Technical Service Bulletin

GROUP	NUMBER
BODY ELECTRICAL	24-BE-020G
DATE	MODEL(S)
DECEMBER 2024	GV70 (JK1A)

SUBJECT: ACTIVE AIR FLAP ON-BOARD DIAGNOSTIC SENSORS REPLACEMENT

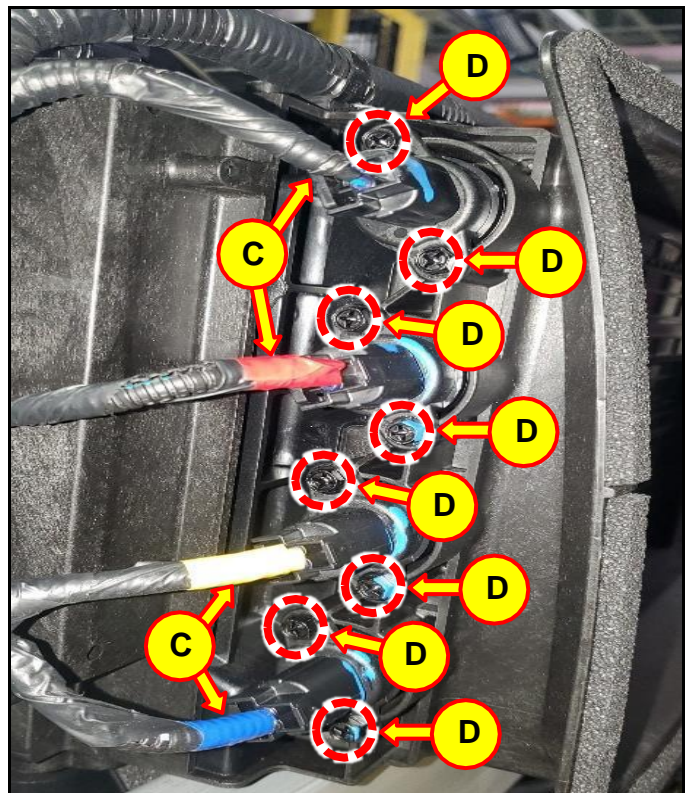
Description: Certain 2025MY GV70 (JK1A) vehicles may experience an illuminated check engine light for DTC P059A from a faulty connection due to improper soldering within the sensor components. This bulletin outlines the procedure to replace the active air flap (AAF) on-board diagnostic (OBD) sensors to resolve this issue.

1. Turn **OFF** the ignition.
2. Disconnect the negative (-) battery terminal (A) by referring to the shop manual:
 - **G 2.5 T-GDI THETA III >Body (Interior/Exterior) > Front Bumper > Front Bumper Assembly > Replacement**
3. Locate 4 AFF OBD sensors (B) on the FEM module.
4. Remove the wire connections (C) and 2 screws (D) from each AAF OBD sensor, shown in the red circles.

6. Install the new AAF sensors with mounting screws and reconnect the connectors.
7. Reinstall all components in reverse order.
8. Reconnect the negative (-) battery terminal.
9. Perform an **All Systems Fault Code** search and erase any DTC history that had incidentally occurred.
